August 22, 2023

To the PAC and ISO-NE,

The proposed X-178 rebuild is not an Asset Condition Project

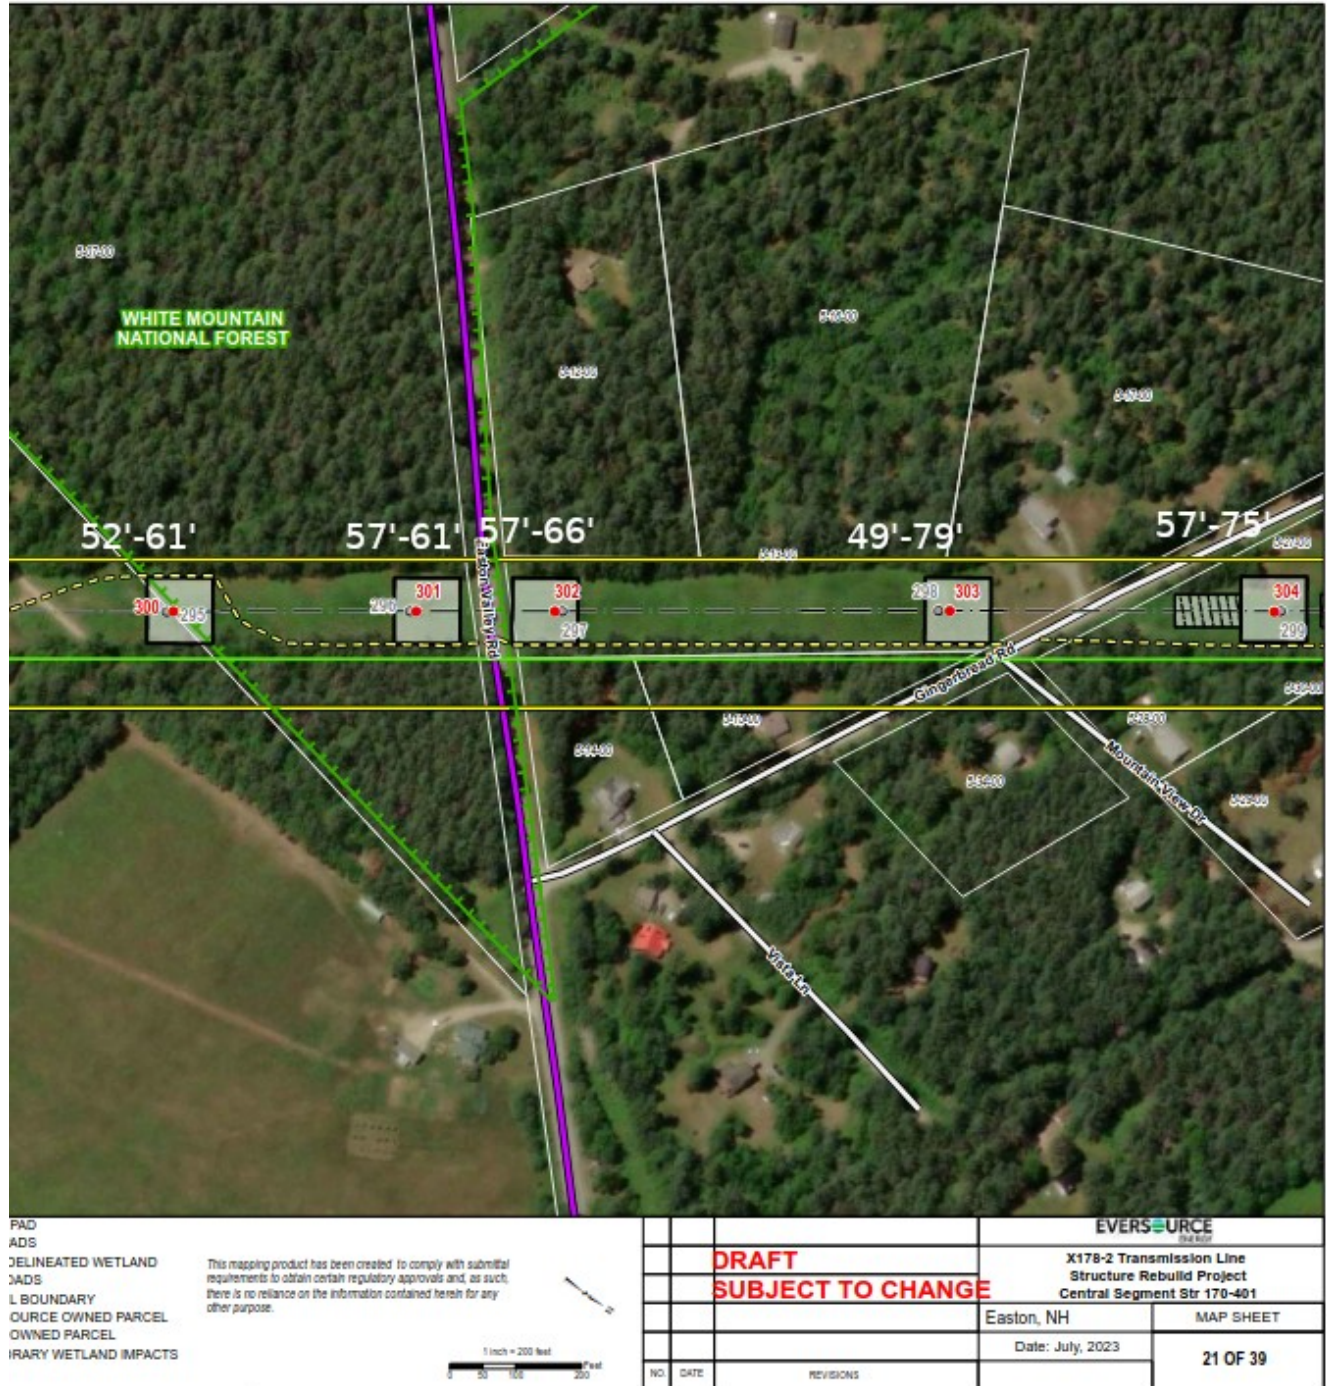
O-154 line before so-called Asset Condition replacement

O-154 line after “upgrade”, with “enhanced” roads.

Proposed pole heights over Gingerbread Road in Easton, (white road) vastly exceeding clearance required by Code. The pole height information is not available to the public, except those pages I photographed at the August 1st Sugar Hill “information” meeting:

Below: Replacing this 49' wood structure with a 79' steel structure means a more than 50% increase in height. Eversource has provided no documentation that this is necessary for clearance or line safety.
